Radian Engineering, LLC  
Mountain Villages

AGENDA ITEM 6  
**PLANNING & DEVELOPMENT SERVICE**  
**PLANNING DIVISION**  
455 Mountain Village Blvd.  
Mountain Village, CO 81435  
(970) 728-1392

**FROM:** Amy Ward, Senior Planner

- NATIVE GRASSES | GENERAL REVEGETATION

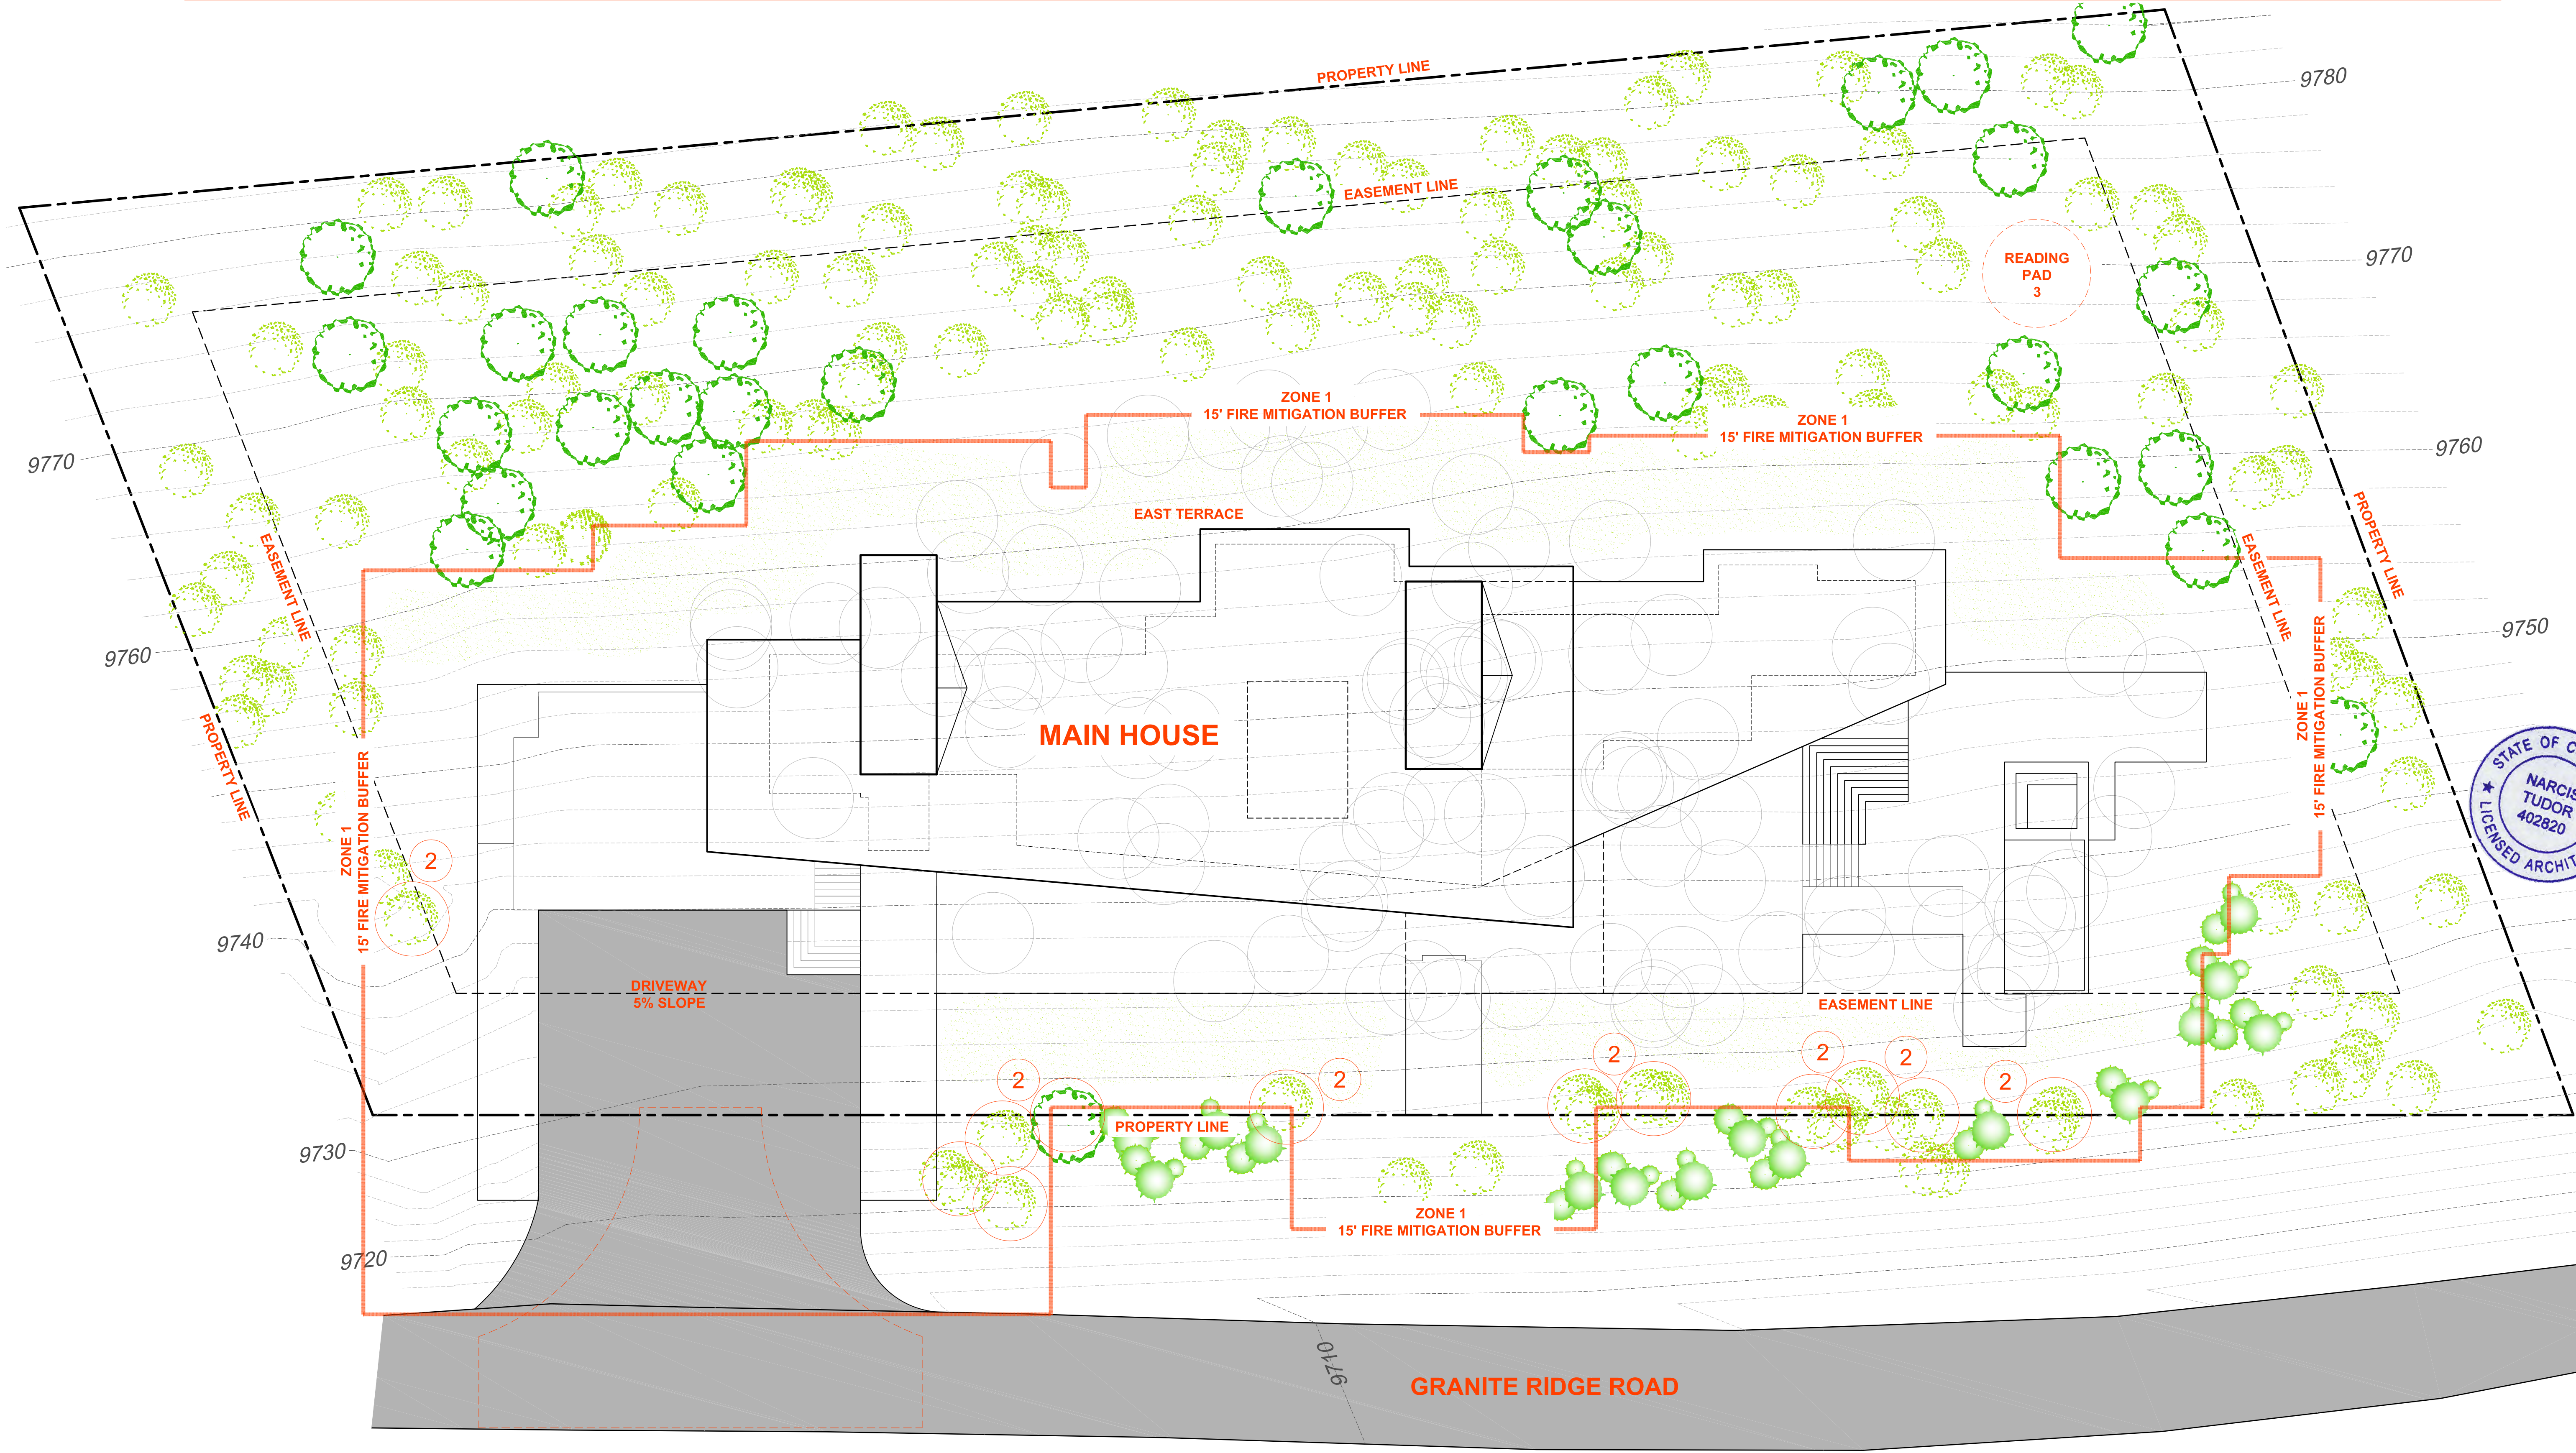
- 6) PRIOR TO FINAL REVIEW THE APPLICANT SHALL CLARIFY WHAT THE FINISHED SURFACE OF THE RE- GRADED AREA UNDERNEATH THE HOME WILL BE. - **SEE SHEET A1.1 - NATIVE GRASSES | GENERAL REVEGETATION**

3 READING PAD DETAIL  
SCALE: NTS

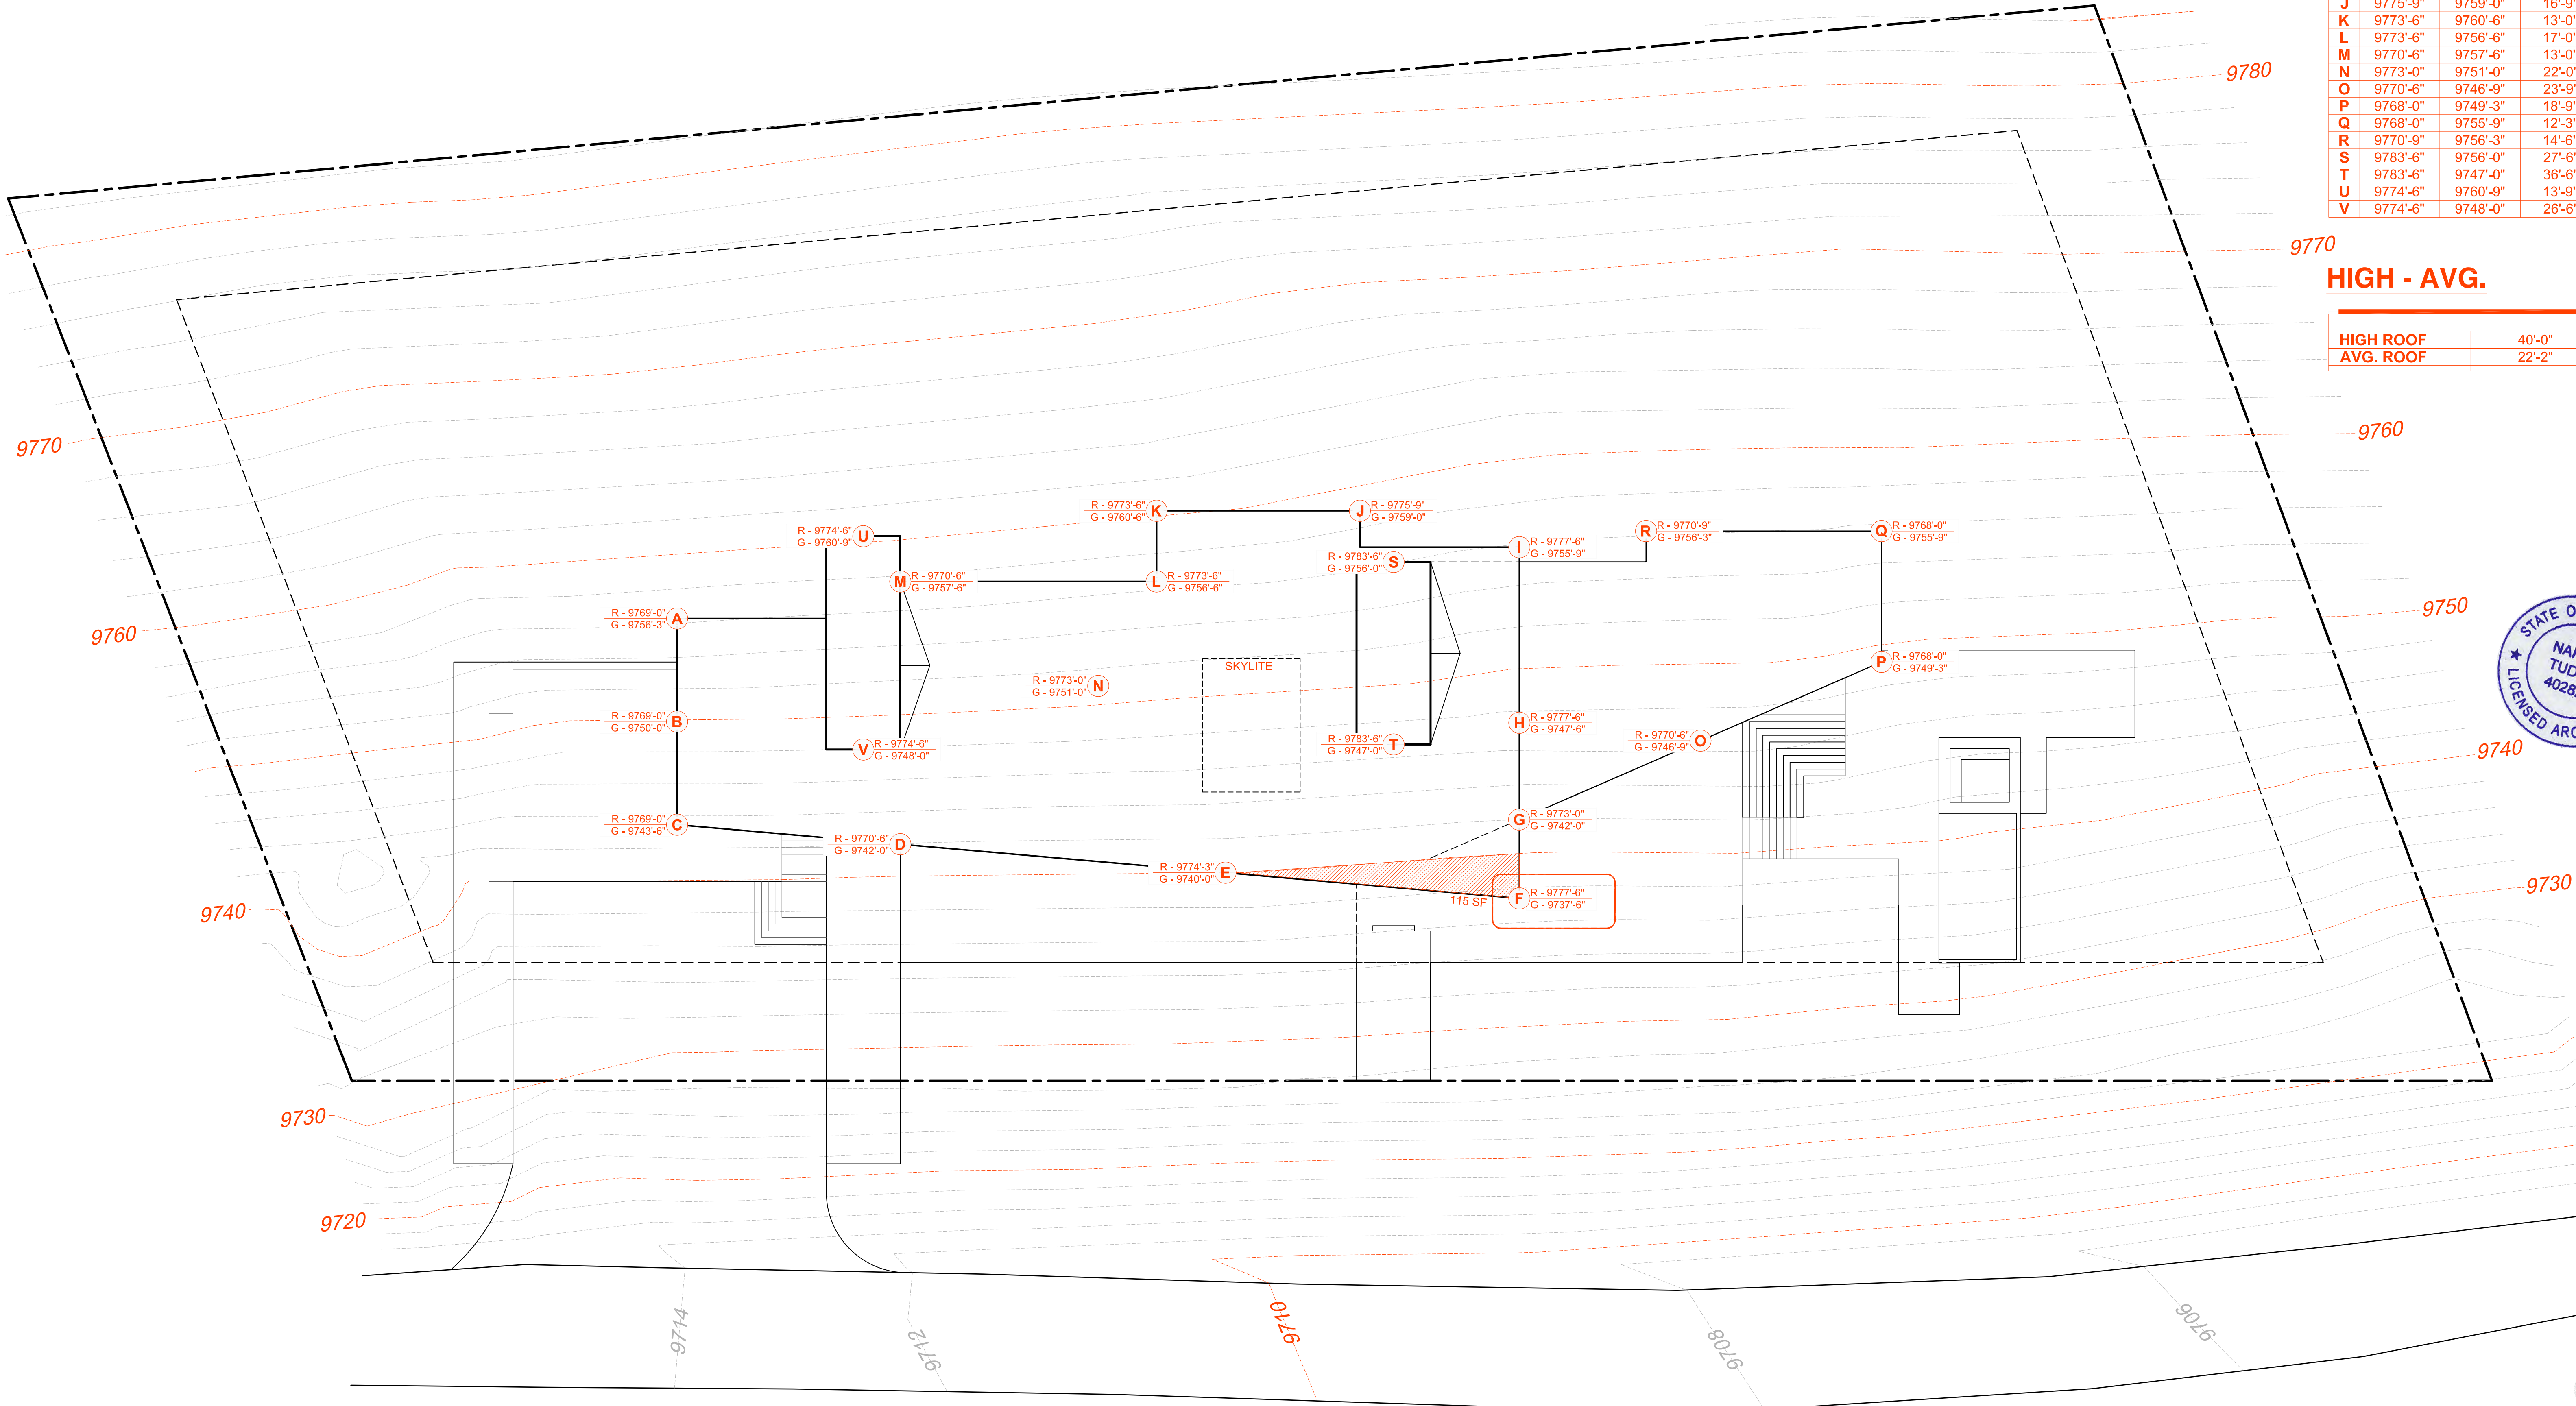
- 2) PRIOR TO FINAL REVIEW, THE APPLICANT SHALL REVISE THE LANDSCAPING PLAN TO PROVIDE DETAIL REGARDING THE PROPOSED "READING PAD." - **SEE SHEET A1.1B**
